**Comhairle Contae Thiobraid Árann**  
Tipperary County Council

# **Chief Executive Officer's Report**

**Part VIII Development,  
Tipperary Hills Regeneration Project,  
Murgasty,  
Tipperary Town,**

**16<sup>th</sup> May 2023**

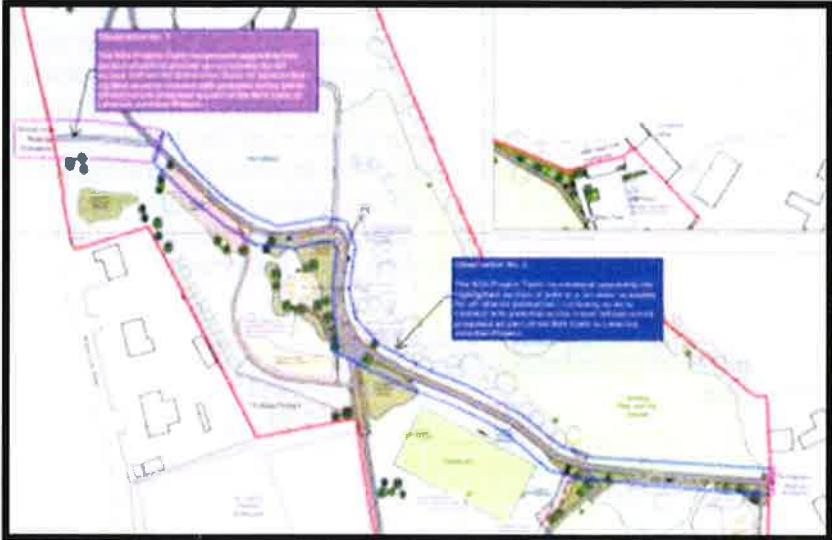
Ref. No.	Date received	Submission Name and Address
1 & 2	24/02/2023	Damien Meade, 131 St. Michael's Avenue, Tipperary Town, Co. Tipperary
<p><b>Summary</b></p> <ol style="list-style-type: none"> <li>1. Inclusion of dog exercise area welcomed.</li> <li>2. Current area identified to the west of the hollow is by far too small for a dog exercise area, it is also too close to the main walkway of the cup and saucer area as some walkers may be fearful of dogs. After some research most countries have a "doggy park" off to the side of a public park where as it doesn't interfere with everyday walkers, the areas are normally square in size as some dogs like to maintain their own space, the current plan makes this impossible as it is so narrow.</li> <li>3. Submission requests that the dog recreation area is placed on the south side of the south wall of the graveyard, this area is already flat with some dead trees which can be easily removed, it's a very open area and off to the side of the hills away from everyone else, there are no homes located here so it will not interfere with home owners in the area, current plan is quite close to a home. The submission suggests that a pathway with steps can be constructed on the south side of the graveyard down to the proposed area. Requested that a gate be provided at the top of this path, handrails for the entire length, and gateway as an entrance to the exercise area.</li> <li>4. Suggested that steel benches be provided within any dog park.</li> </ol>

1. Noted.
2. The location of the proposed dog exercise area south of the motte has been considered carefully. It is 410 sq m in size, is universally accessible, and is seen as an add on to the dog walking facilities that the Tipperary Hills already provide to local dog owners. It is an area where dogs can be released from their harness and lead for a short time, to wander and socialise with other dogs safely, and separate from other users of the site. It is envisaged that dogs and their owners could use this secure area for 10-20mins, as a stopping off point on their usual route. It is a relatively level area that does not require extensive levelling, grading or preparation to make it suitable for this use. An appropriate gravel surface is being installed to reduce the prevalence of dirt and muck in the wet. Planting can be provided on the outside of the proposed fence to prevent children putting their hands through same.

Planting to be included for on the outside of the fence surrounding the dog park.  
One seat will be provided at this location.
